Agenda Item: 7K Subject: Code for Canals Date: Dec 2/24

Agenda Item: 7 Subject: 592+582 Ranger Date: 12-2-24

Appeal of Departure Request 582 Ranger Lane & 592 Ranger Lane

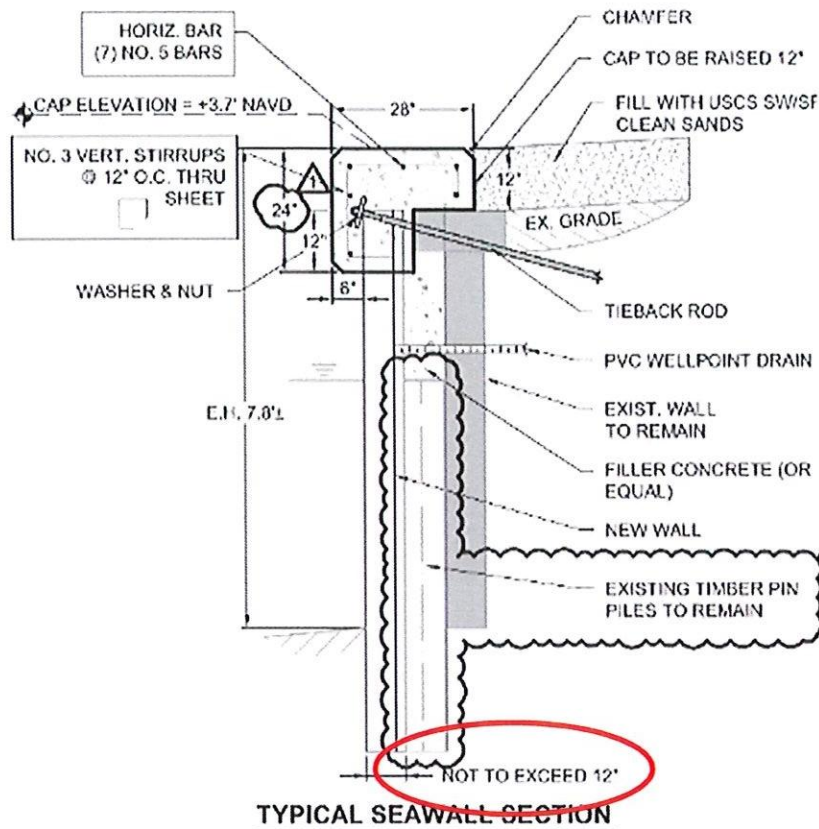
3. March 1, 2024. Revised Change Order plans submitted with plans. Section view detail (provided below) did not indicate the dimensions of the timber pin piles, nor did it indicate that the new corrugated seawall could not be constructed around or otherwise incorporate the existing timber pin piles within the maximum Town Code required 12 inches as required by Town Code Section 151.03. Staff approved plans on March 6, 2024, with a Condition of Approval, on the Permit Card, that the new seawall not protrude more than 12 inches waterward of the existing seawall. The Condition of Approval allowed for construction of the new corrugated seawall to be accomplished by working around or incorporating existing

timber pin piles. An annotated excerpt from the Section View revised plans indicating a “not to exceed” 12-inch seaward extension of the new seawall submitted to the Town is shown below.

Plan Section View Provided as Part of May 10, 2024 Submittal

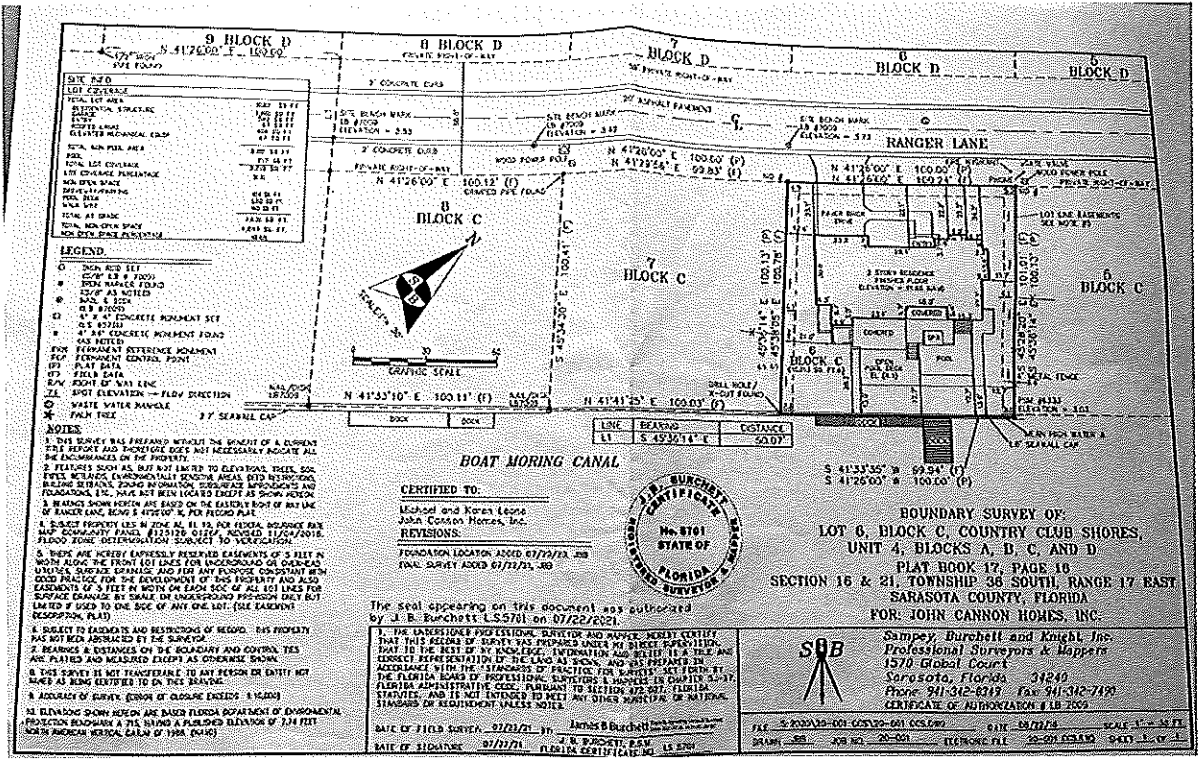
10. May 13, 2024. The Town issues a Stop Work Order due to the replacement Seawall exceeding Town Code requirements of Sec. 151.03(B)(3)(a).

The "Approved" Drawings Did Not Accurately Depict the "Extension" of the Seawall onto Leone Property at 592 Ranger

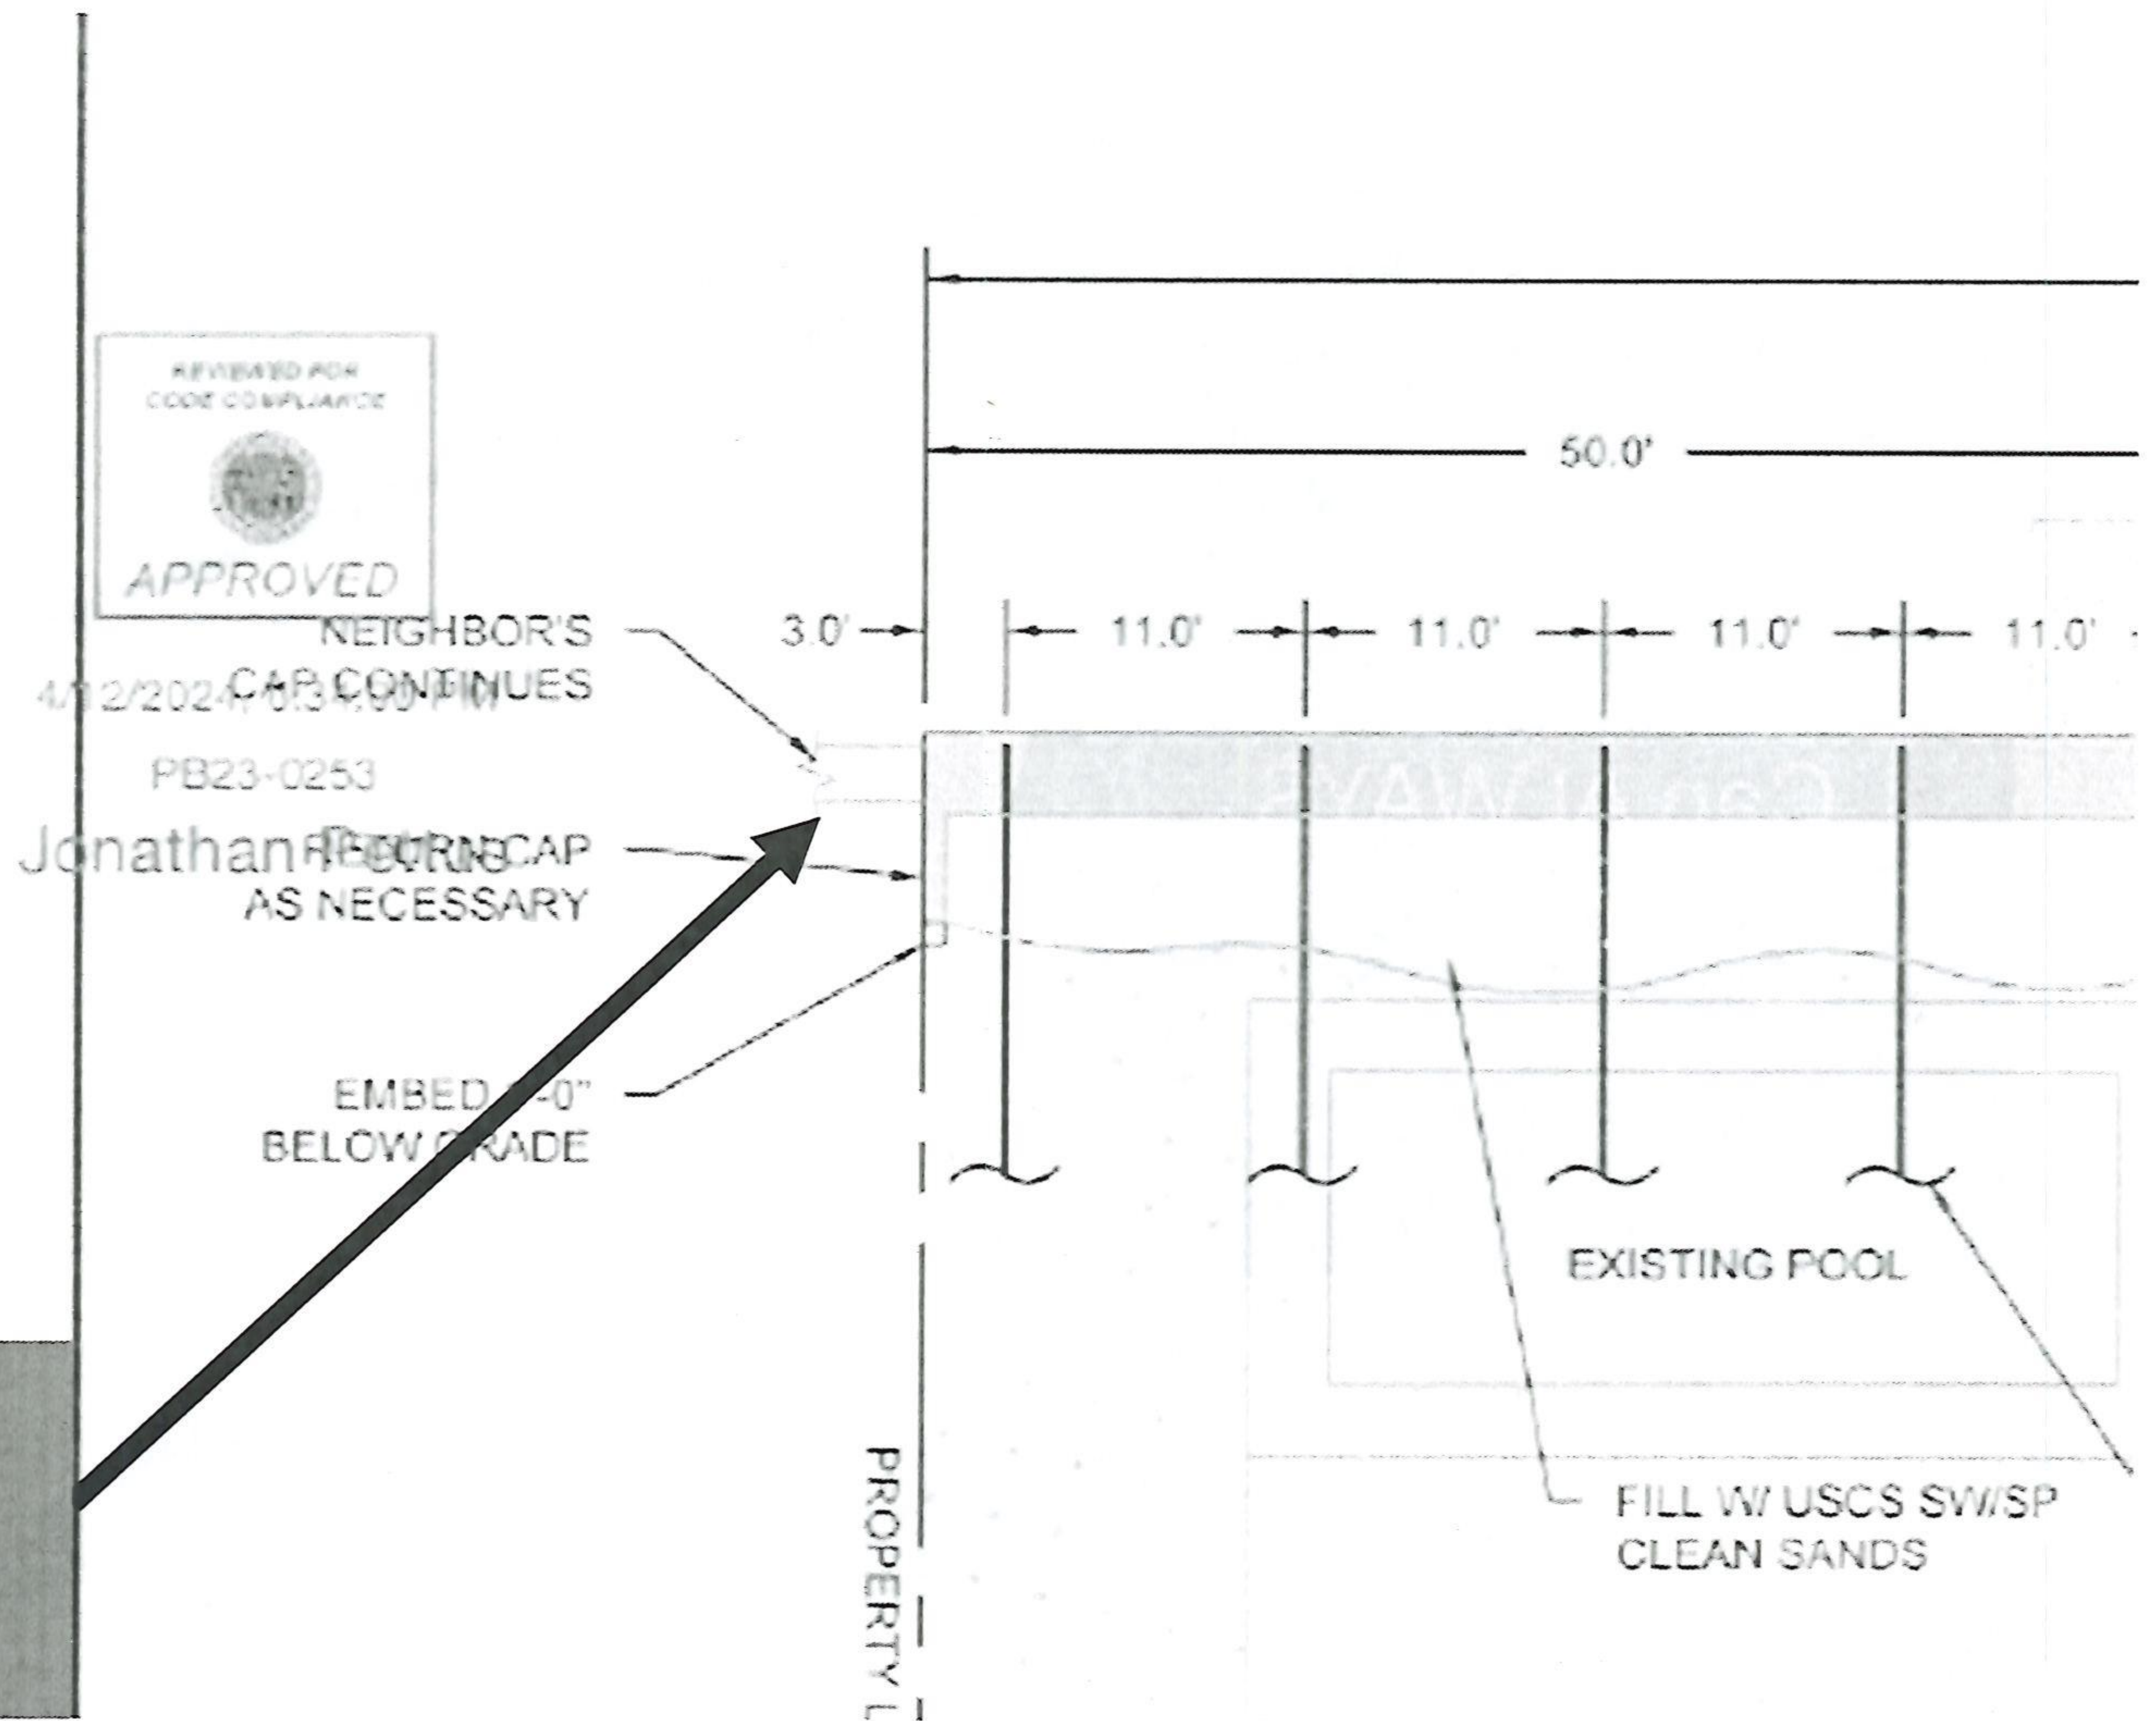
New Seawall Face 12" from Old Seawall

But the seawall at 592 does not reach the property line – 2016 survey found 1.6' gap – now measures at 32"

The May 10 Plan Did Not Comply with Code – exceeds 12"

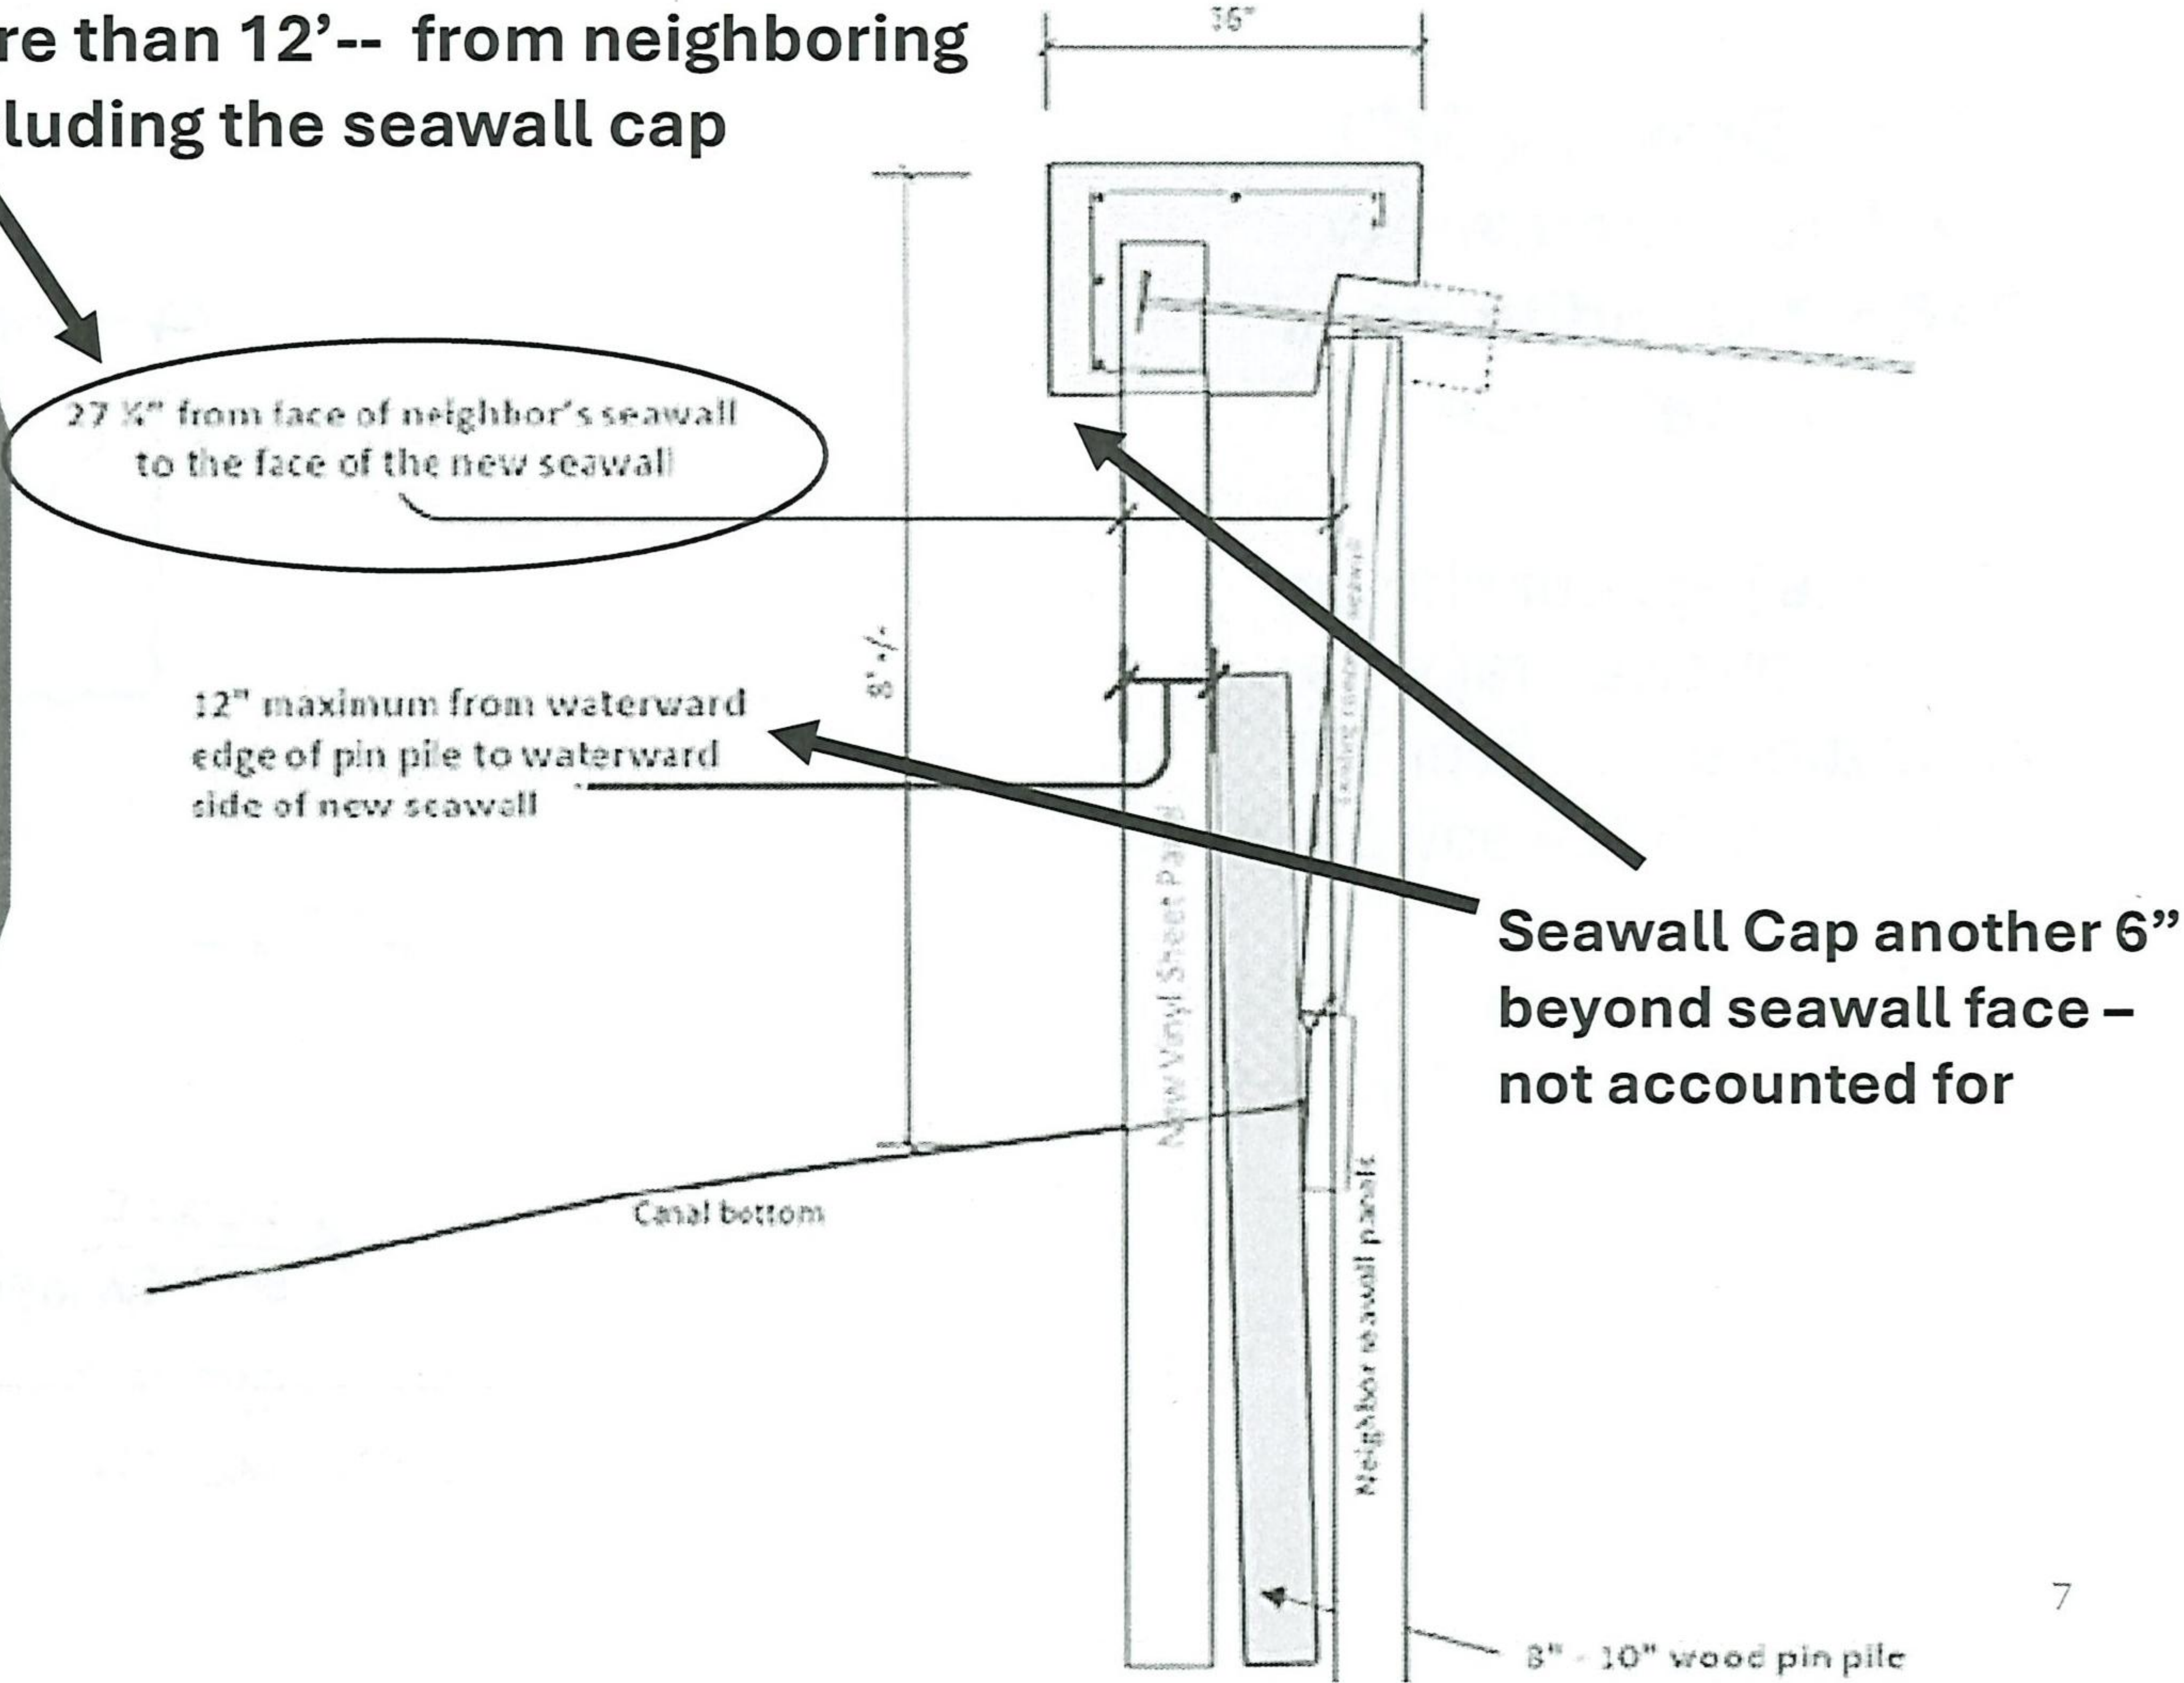
Face 27.25" -- more than 12'-- from neighboring seawall – NOT including the seawall cap
